Product Bulletin

Document #:PB24397X1 Issue Date:07 Oct 2022

Title of Change:	Update for PB24397X - to identify specific sites affected with the change including the transition period			
Effective date:	07 Oct 2022			
Contact information:	Contact your local onsemi Sales Office or KrisJudelo.Dayna@onsemi.com			
Type of notification:	This Product Bulletin is for notification purposes only. onsemi will proceed with implementation of this change upon publication of this Product Bulletin.			
Change Category:	Test Change			
Change Sub-Category(s):	Shipping/Packaging/Marking			
Sites Affected:				
onsemi Sites		External Foundry/Subcon Sites		
onsemi Cebu, Philippines		Greatek Electronics Inc., Taiwan		
onsemi Leshan, China		HANA Microelectronics, China		
onsemi Seremban, Malaysia		JCET, China

Sample marking change below

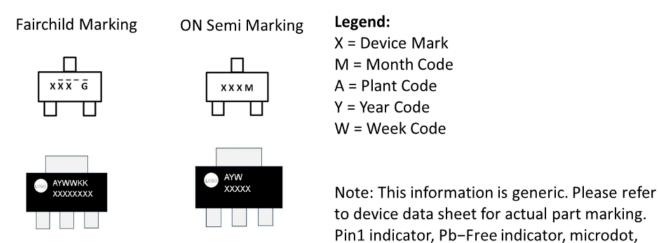
This update to PB24397X is to list all of the affected sites and clarify that the transition period will be until Dec 31,2022. SOSM and SOT223 package assembled in various listed sites will start to use onsemi Marking Layout Configuration

For a specific OPN that is build in different sites will now have the same lay out scheme and will just differ on the plant code.
